MTF FOM Alignment Proposal

Sam Kocsis, Hansel D'Silva Amphenol

Related to comments #604, 605

Determining a Practical Transition Time

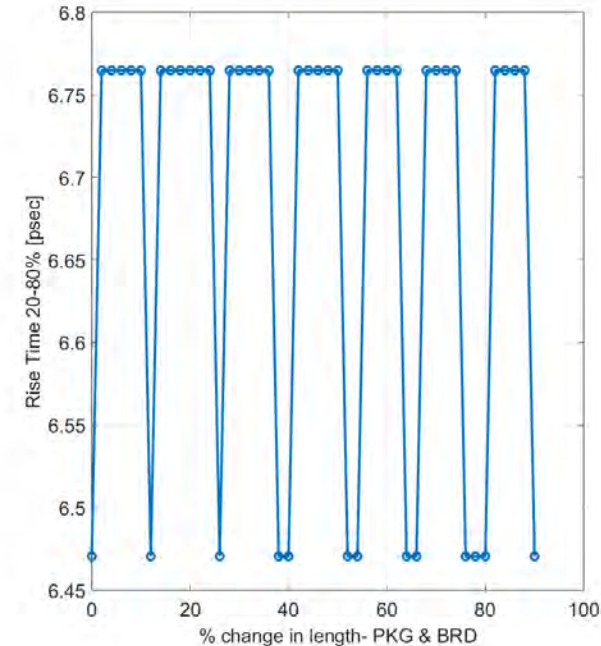
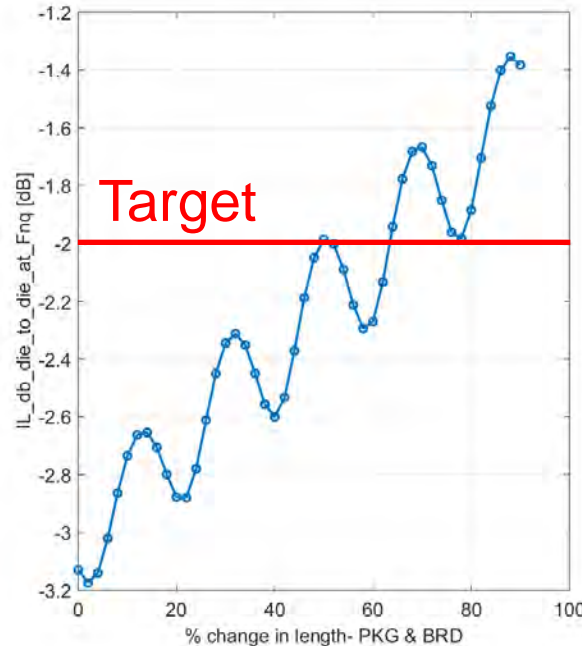
- What is the fastest rise time that we could see at TP1?

1. Start with HL case,
PKG= 8 mm
BRD= 9 mm
2. Reduce loss to
informative minimum
3. Observe transition time
at MDI connector input

IEEE Project	COM Transmitter Transition Time – Tt (ps)	FOM Transition Time - Tt, Tr, Tnt, Tft (ps)	Delta Time (%)
802.3ck	6	7.5* (Tt for ERL)	25
802.3dj	4	5	25
